Project Description:	Northwin Landfill Phase 1 West	Contract No.:	Click or tap here to enter text.
		Project No.:	11222680
Submitted by:	Upland Contracting Ltd.	Submittal #:	001

Shop Drawing Review

NORTHWIN LANDFILL WEST CELL SECONDARY LINER

SW - 315

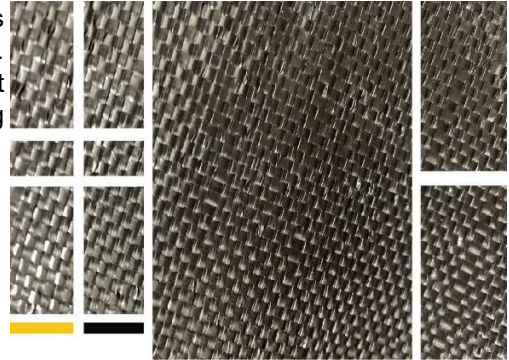
Puncture Strength spec: ASTM D4833, Submittal: ASTM D6241

ASTM D6241 is acceptable as an alternative to ASTM D4833.
Product meets GRI standard specification for CBR puncture strength for a high survivability geotextile.
